## Determination 2011/109

### Refusal to issue code compliance certificates for alterations under two building consents to a house at 668 Weedons Road, Christchurch

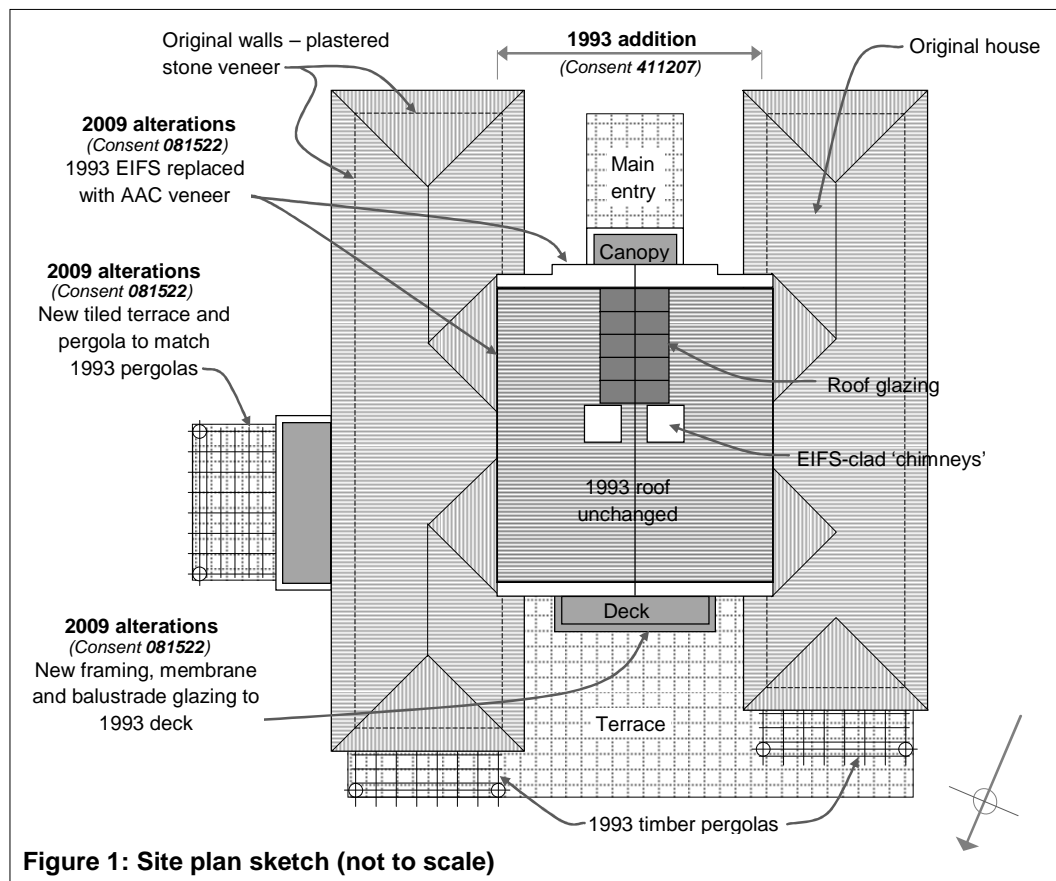
2.1 The building work consists of alterations to a detached house situated on a large level rural site in a high wind zone for the purposes of NZS 3604<sup>4</sup> that is moderated by tall trees that surround the site. The original house appears to have been built as a single-storey building with stone veneer cladding, aluminium windows, and metal roofing. The alterations are shown in Figure 1:

2.4.1 As shown in Figure 1, and as based on the drawings of the existing house included in the 2009 consent drawings, the 1993 alterations appear to have included:

2.5.1 As shown in Figure 1, the 2009 remedial work included:

Figure 2: Simplified sketches of windows (not to scale)

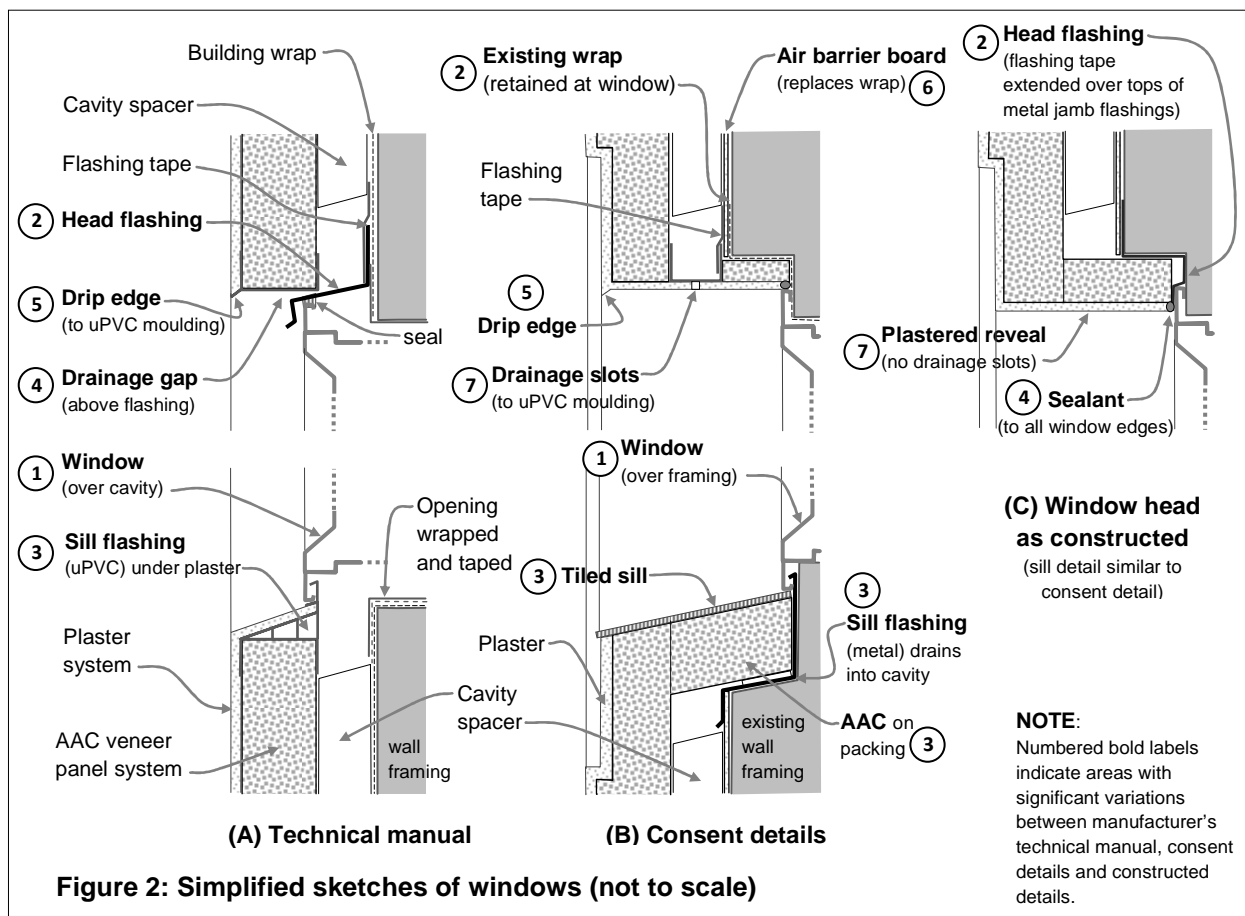
2.5.5 The simplified sketches in Figure 2 contrast details in the manufacturer’s technical manual (A) with 2009 consent drawings (B) and the as-built installation (C), and highlights variations between the details. The following descriptions provide references in brackets to the significant areas of difference.

...the window sill flashings that drain into the cavity do not comply with the Building Code. Neither do they comply with the [AAC veneer system manufacturer’s] technical manual; notwithstanding the producer statement from [the manufacturer] dated 15 September 2009 confirming that the work complies.

7.4.1 With regard to the authority's concern about the sill flashing discharging into the drained cavity behind the AAC panels, I make the following observations:

- The installed sill flashing turns down over the RAB into the AAC cavity, with a kick-out to direct moisture away from the RAB (see Figure 2).

7.4.2 However, I note that the expert was not given the opportunity to verify the performance of the flashings by undertaking invasive moisture tests of the timber framing. While I can take the features of the above into account, I am unable to make a decision regarding compliance of the sill flashings with the Building Code at this time: I discuss a suitable methodology that can be used to determine compliance in paragraph 7.5.3.
